CITY of NOVI CITY COUNCIL

Agenda Item 1
March 17, 2008

SUBJECT: Consideration of the request of Best Buy for Preliminary Site Plan and Special Land Use approval. The subject property is located in Section 14, on the east side of Novi Road, between I-96 and Twelve Mile Road. The subject property is approximately 3.3 acres and the applicant is proposing to remove the closed bank and furniture store and construct a 30,891 square foot Best Buy store.

Preliminary Site Plan and Special Land Use Request

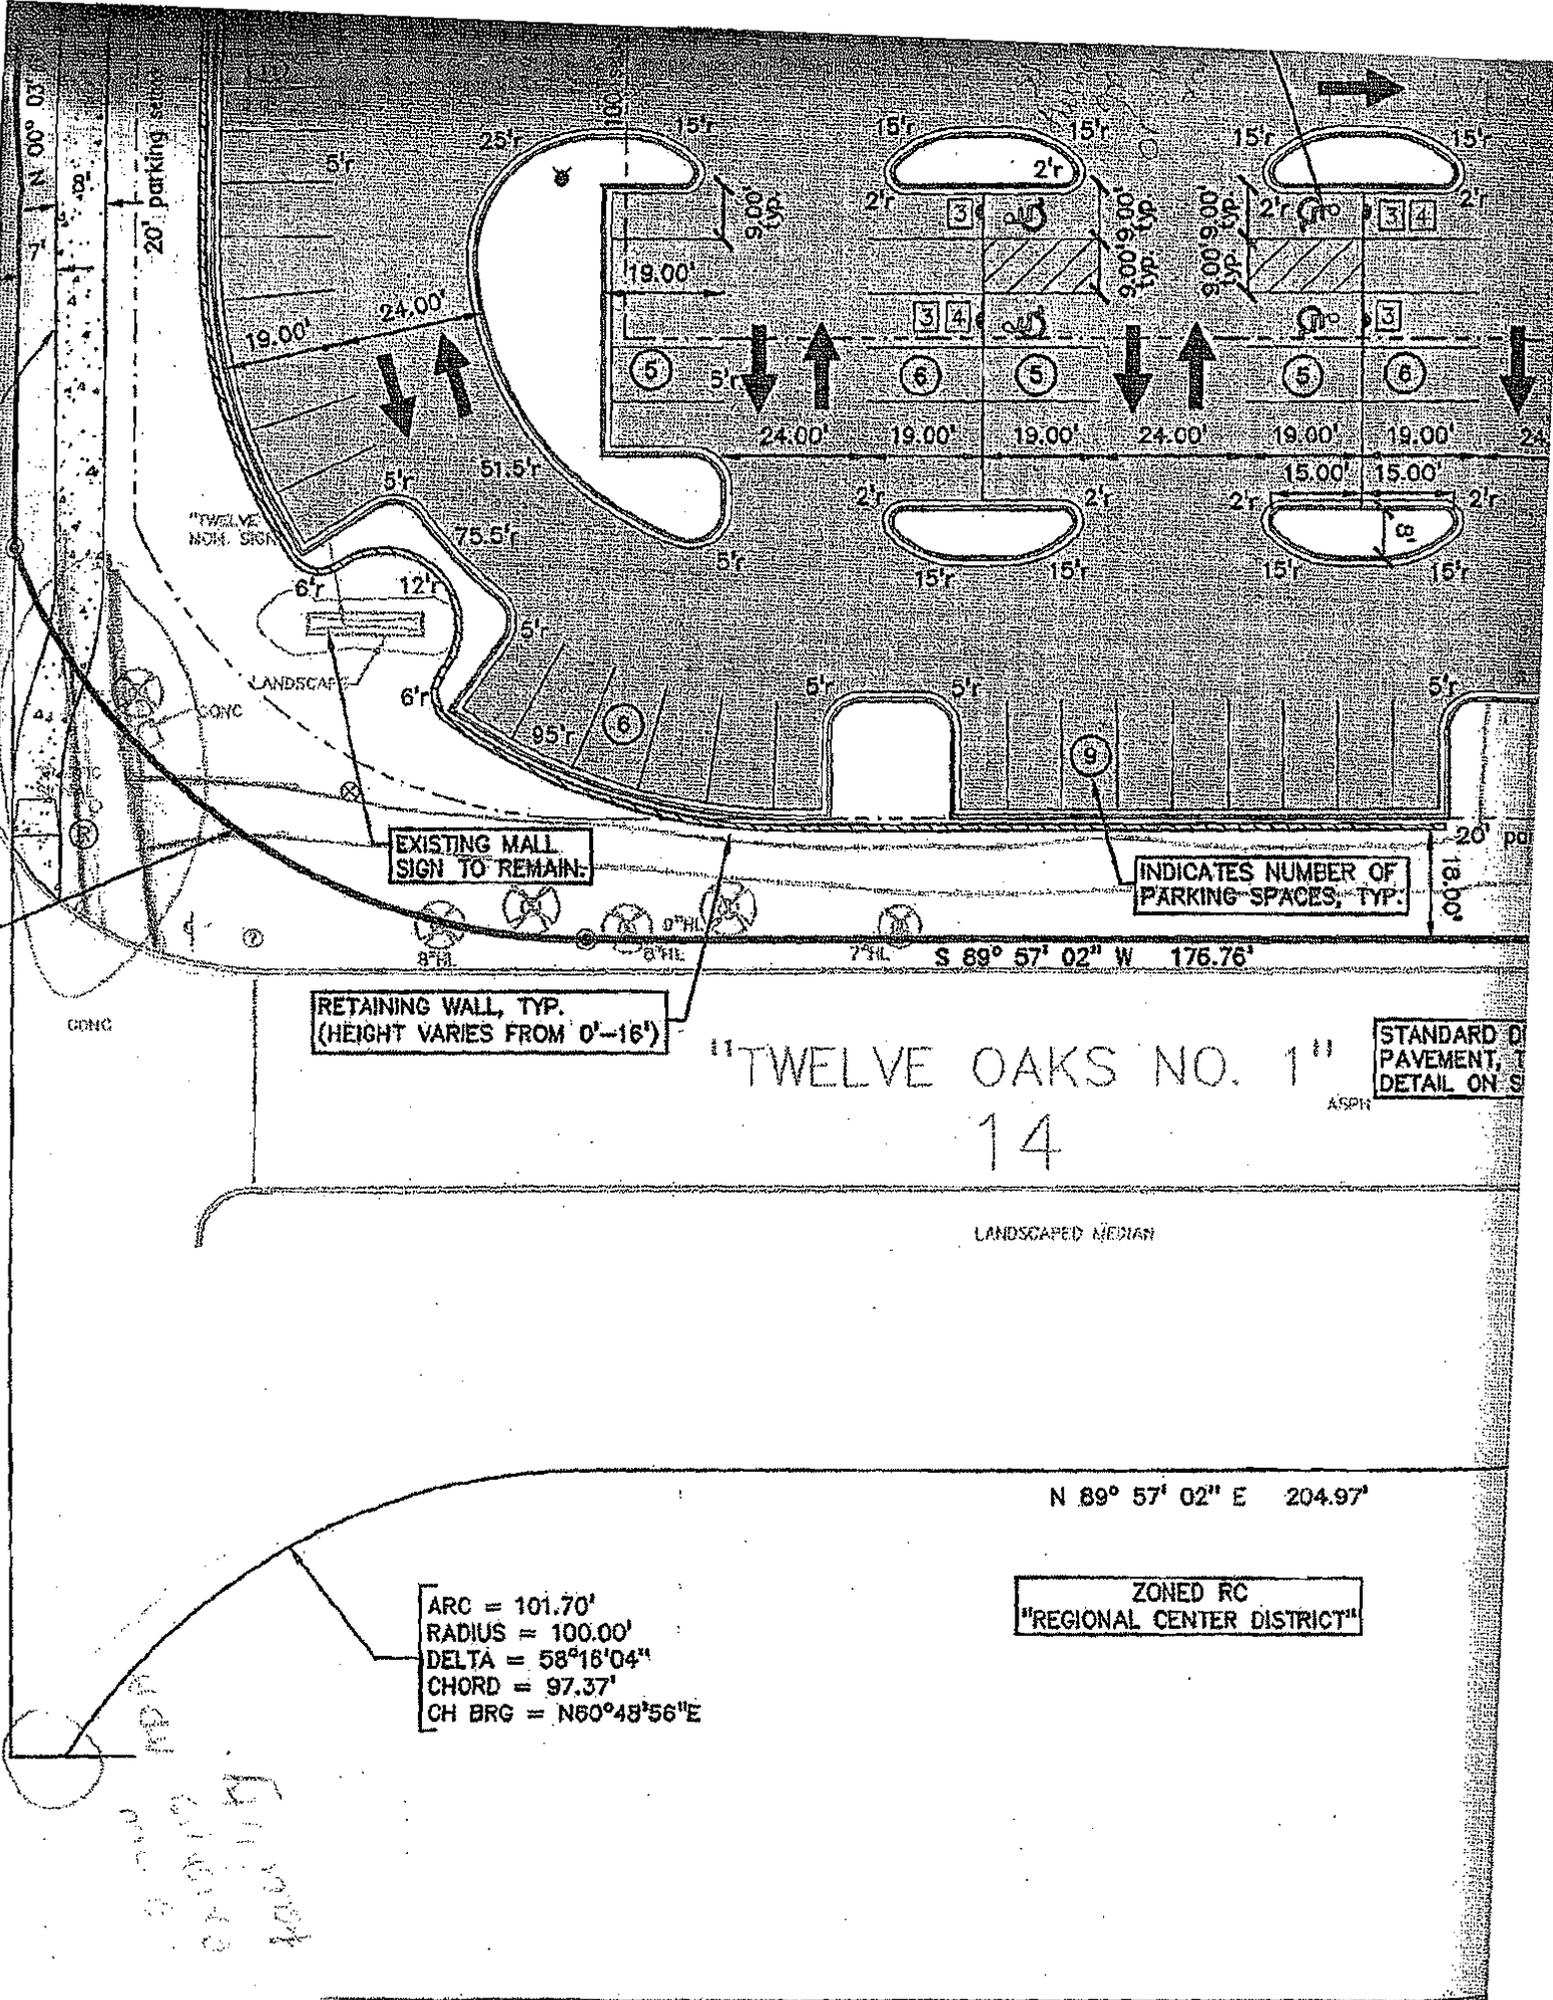
6. Signs: The correct MMUTCD sign code for the "NO PARKING FIRE LANE" sign is R7-9a (mod). This correction should be made on the site plans. Also, the message "NO PARKING" should be represented graphically.

7. Sign Mounting Height: The mounting height of all signs should be 7' from the grade level to the bottom of the parent sign. The correction should be made for "Sign and Post Installation in Paved Areas" detail on sheet SP-5.

8. Sign Quantity Table: The sign quantity table should be updated based on revised barrier-free parking provisions.
